**CENTER FOR DRUG EVALUATION AND
RESEARCH**

208276Orig1s000

CLINICAL REVIEW(S)

Device Name P140032 - RIS – Remodulin Implantable System [SynchroMed implantable pump]

Figure 1-1: Remodulin Implantable System

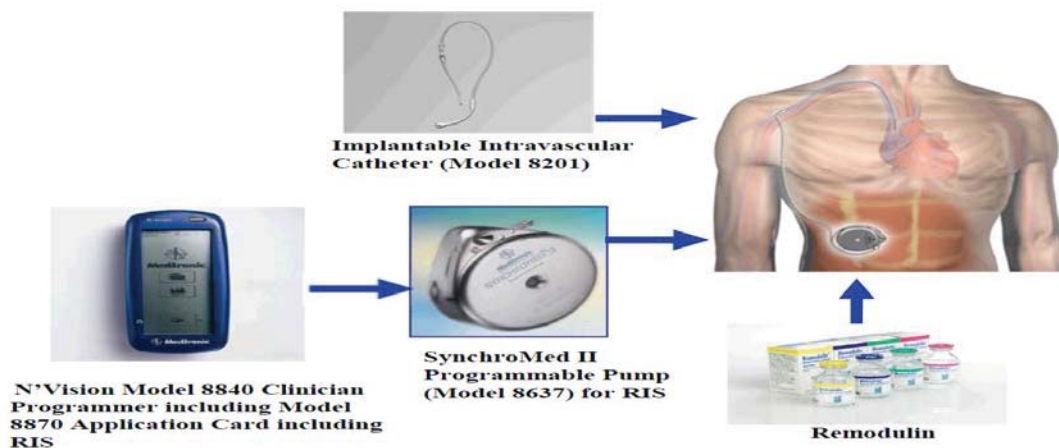
Catheter: Reviewer comments: *Of significant note, the catheter that is being proposed for marketing in the RIS system (Model 8201) is not the same one that was used in animal or clinical studies (Model 10642). Note the excerpted portion of the Table below from the submission,*

Figure 24 Plasma Treprostinil Levels (K2 and K3 Samples)

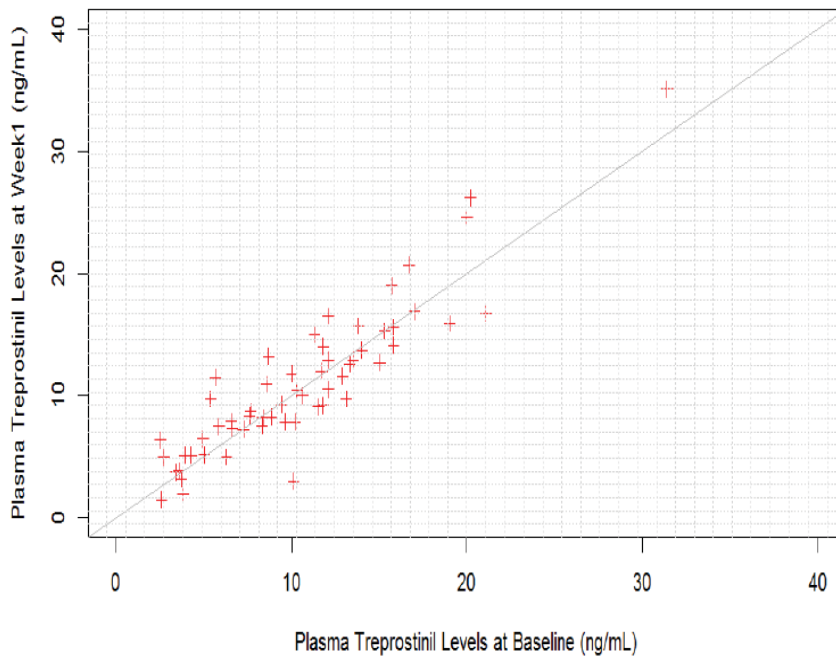
Reviewer comments: *This reviewer must defer evaluation of treprostinil levels to CDER as this reviewer does not have the background for determining if this range of fluctuation is acceptable (though Sponsor points out that this is acceptable in a chronic implant pump)*

Figure 7. Kaplan-Meier Plot of Survival

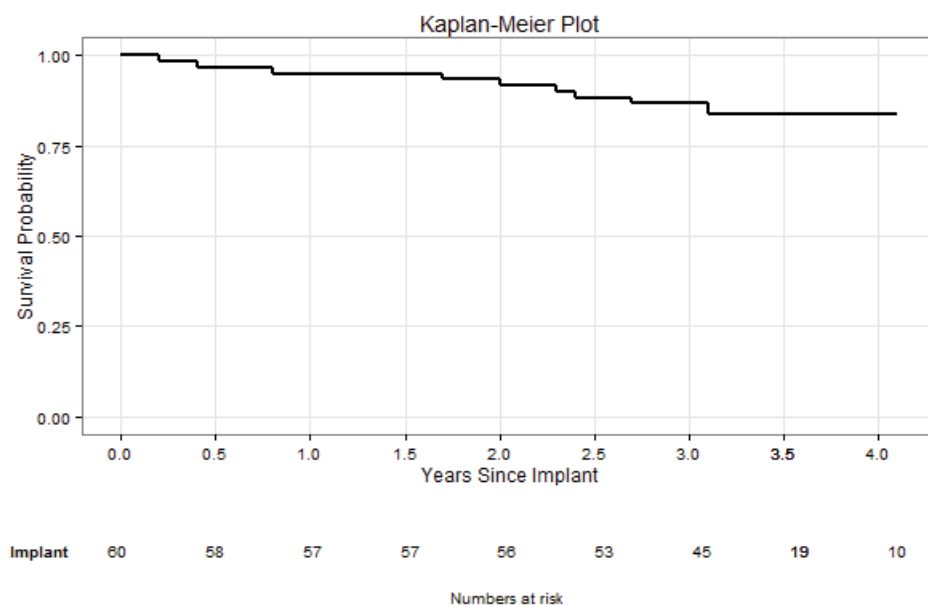
Reviewer’s comment: Mortality rates in this trial appear in the same range to the rates reported in uncontrolled long-term trials of treprostinil. Per the Tyvaso label, the Kaplan-Meier estimates of survival at 1, 2, and 3 years were 97%, 91% and 82%, respectively, in the open-label extension to the pivotal trial. Per the Orenitram label, survival was 92%, 87% and 82% at the end of 1, 2, and 3 years.

Figure 10. Line Plot of the Change in Remodulin Dose over Time for Individual Subjects

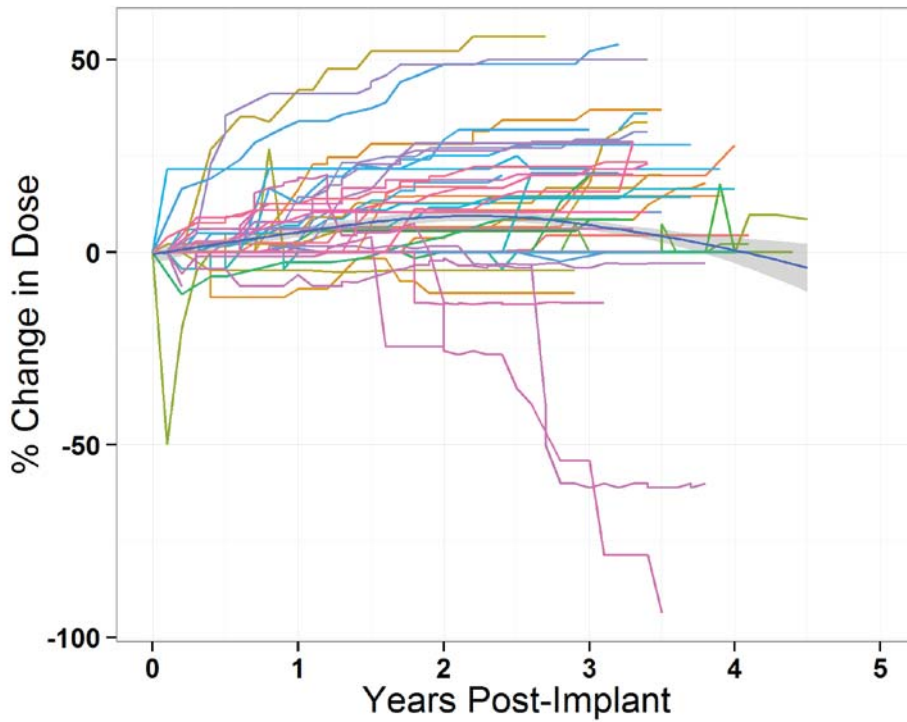
Reviewer's comment: It is not clear whether the increase in dose is related to the decrease in accuracy ratio or normal clinical management of PAH subjects. According to the Orenitram USPI, the dose of Orenitram continued to increase over time.
